Fwd: CH 25 comments

From: Hannes Stueckler <hannes.stueckler@wyo.gov>
Date: Mon, Feb 4, 2013 at 5:07 PM
Subject: CH 25 comments
To: William Tillman <william.tillman@wyo.gov>

To: Bill Tillman
 From: Ronald Ewald, Assistant Southeast District Engineer
 Water Quality Division, Wyoming DEQ
 Date: February 27, 2013
 Subject: **DRAFT2 Chapter 25 – Comments, Questions, and Concerns**

FIGURE 1

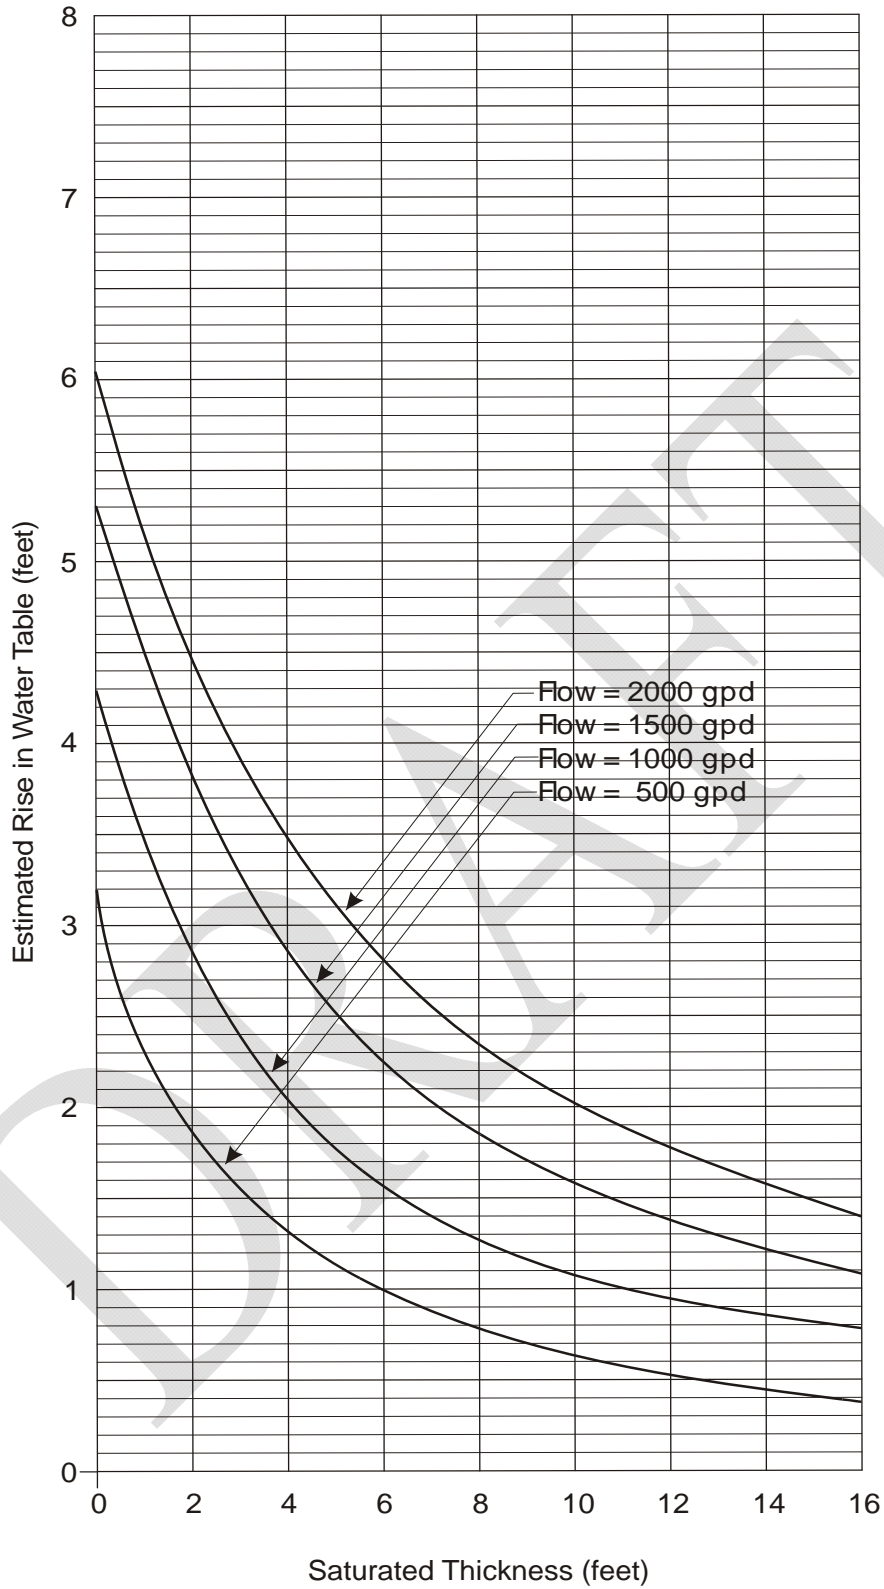
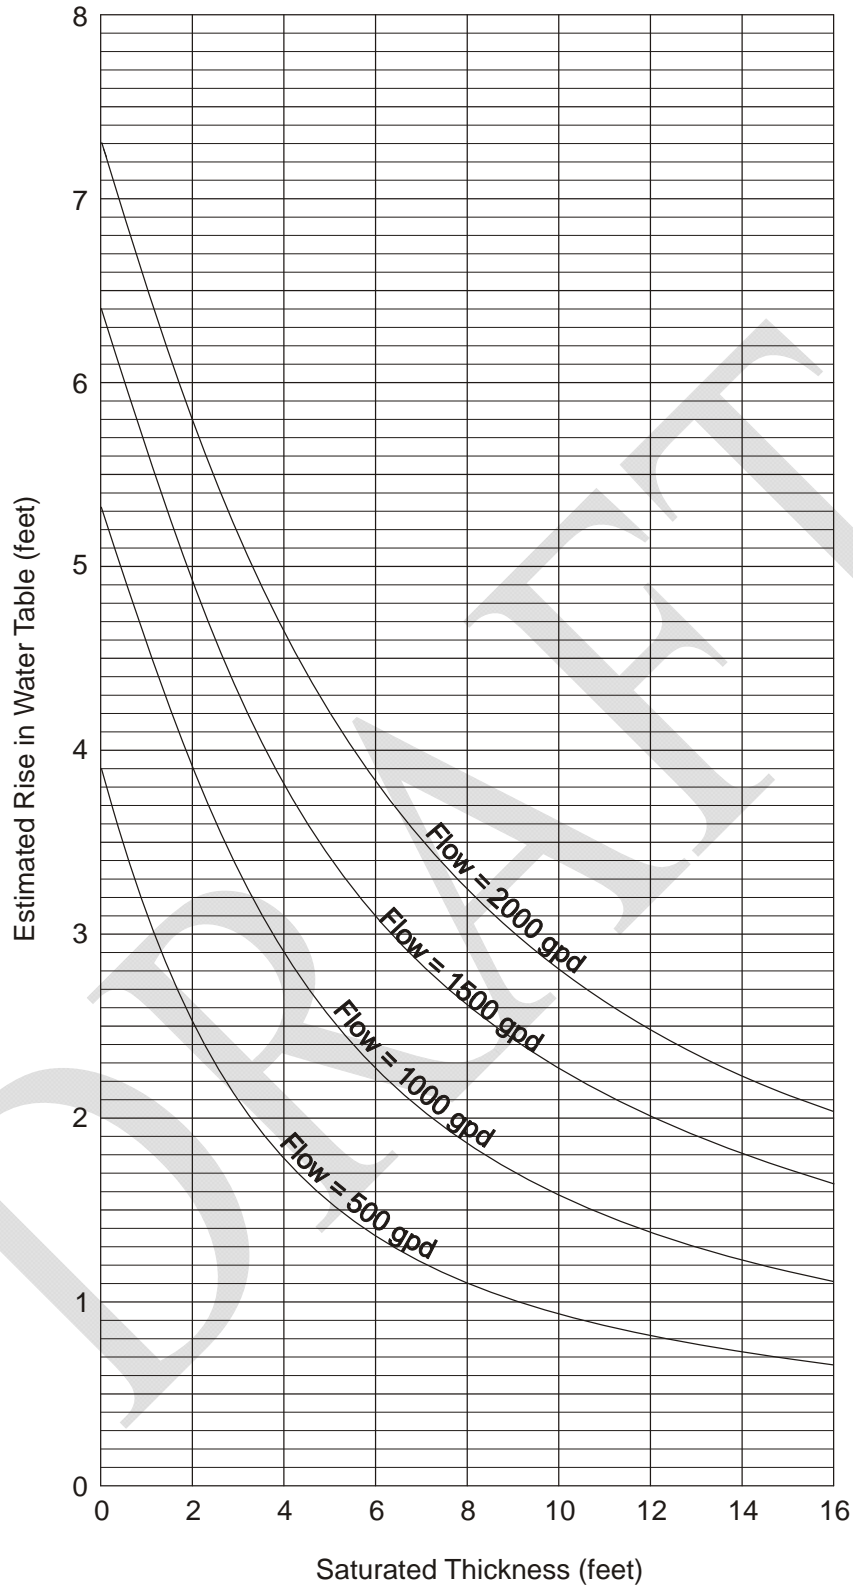
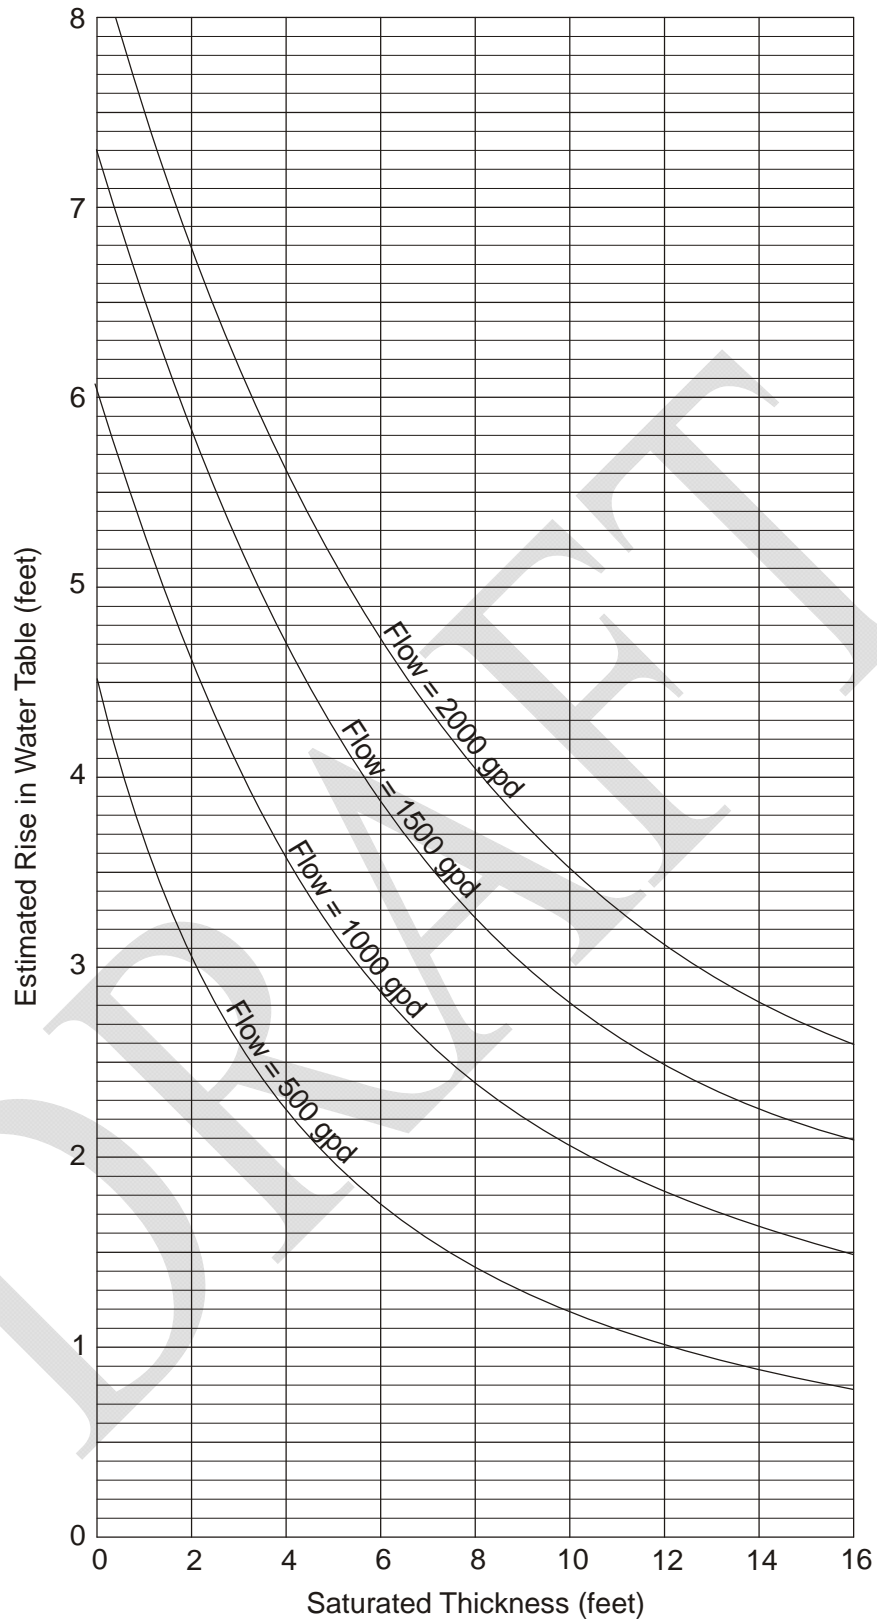
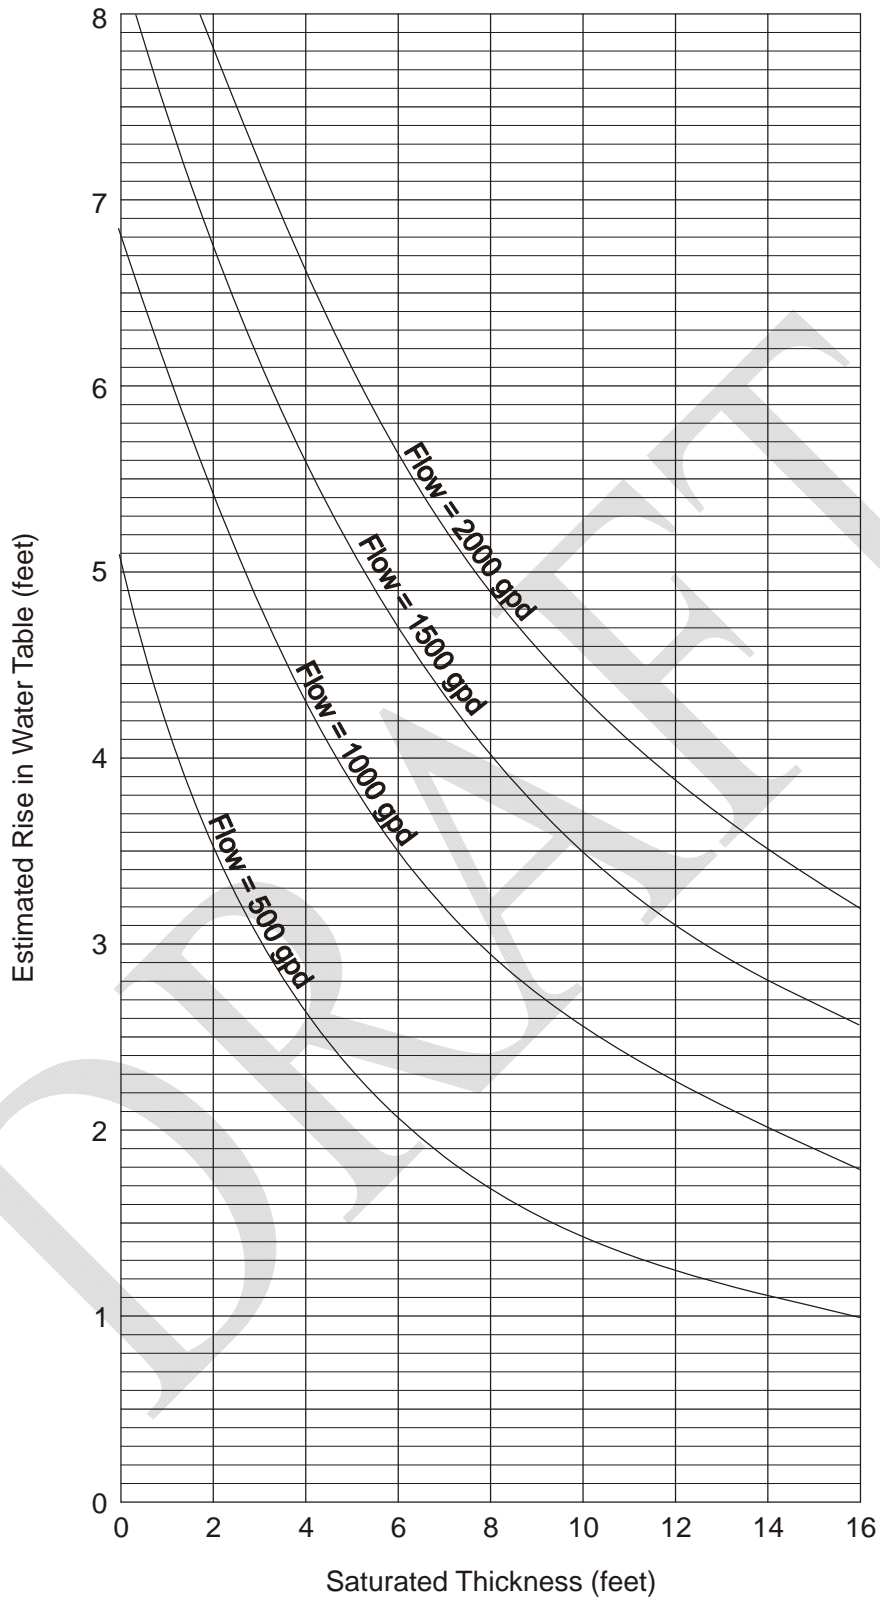
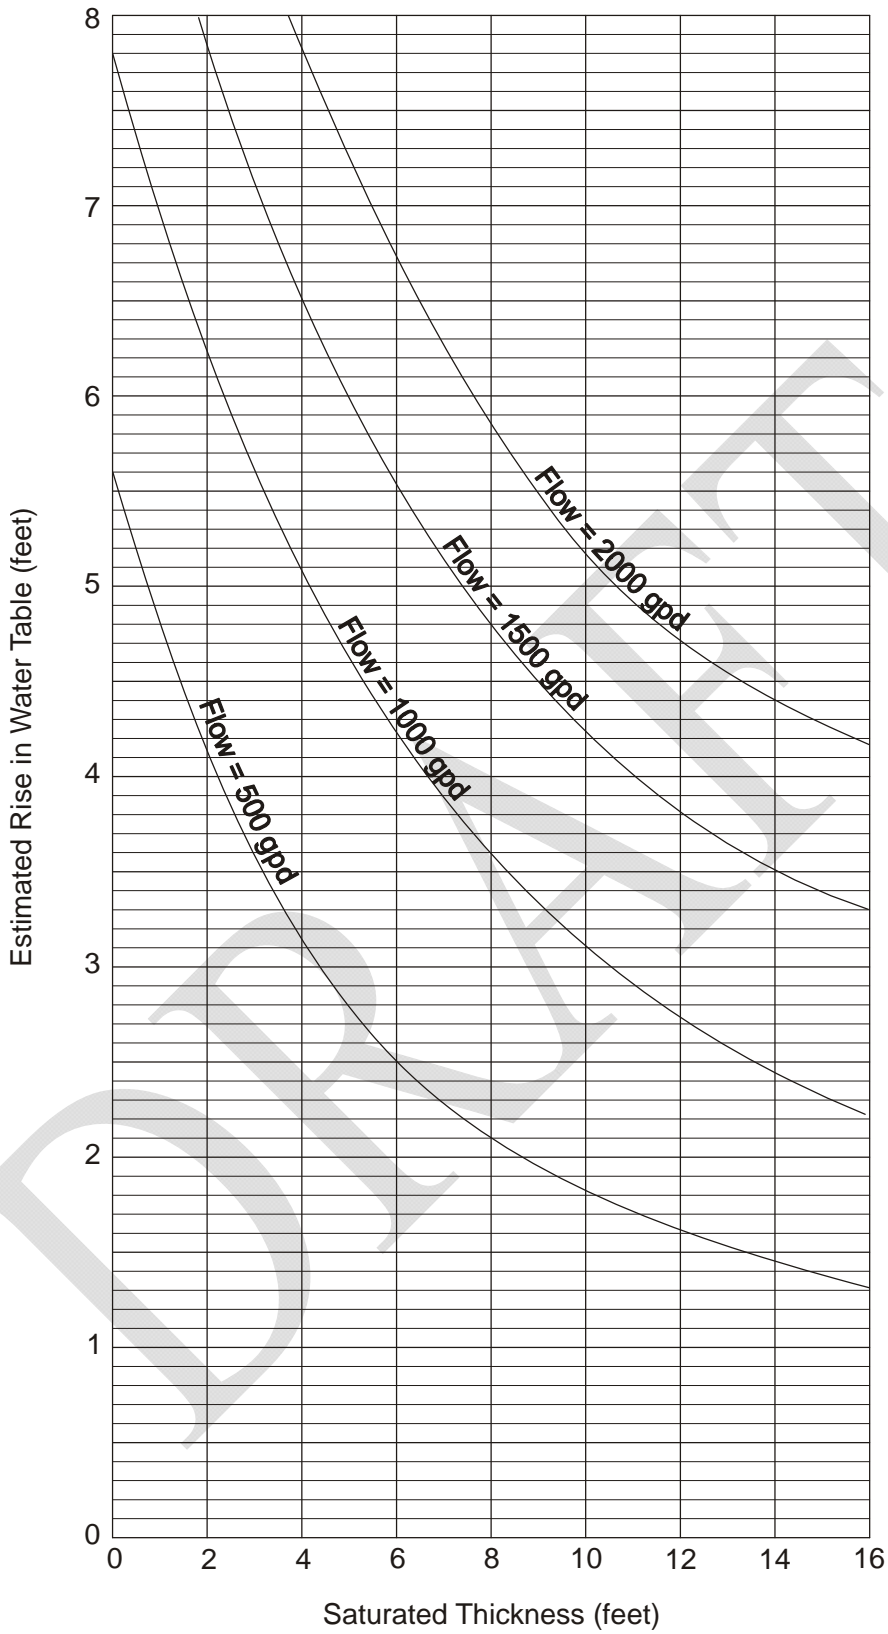
(d) Question: Is the mounding from figures 1 - 6 to be added to the 4 foot separation requirement under all circumstances? This would mean that our ground water separation distance requirement for a typical residential application would have increased from 4 feet to between 4.2 and 9.5 feet. This is contrary to practices found elsewhere and to evidence indicating that four feet may be too conservative.

Are the Estimated Rise in Water Tables really needed? If they are used, the definitions of Saturated Thickness and Estimated Rise in Water need to be added.

Under Section 6. Site Suitability. In item (d) reference is made to the estimated rise in the water table shown on figures 1 through 6. There needs to be an explanation of what is meant by the saturated thickness and how and when it is to be used along with the basis for figures 1 through 6. What is the source of these figures is it analytical, empirical or statistical or some other results? For example if there is no ground water present below the proposed leach field the saturated thickness curves indicate a rise in the groundwater level. How can there be a rise if there is no groundwater?
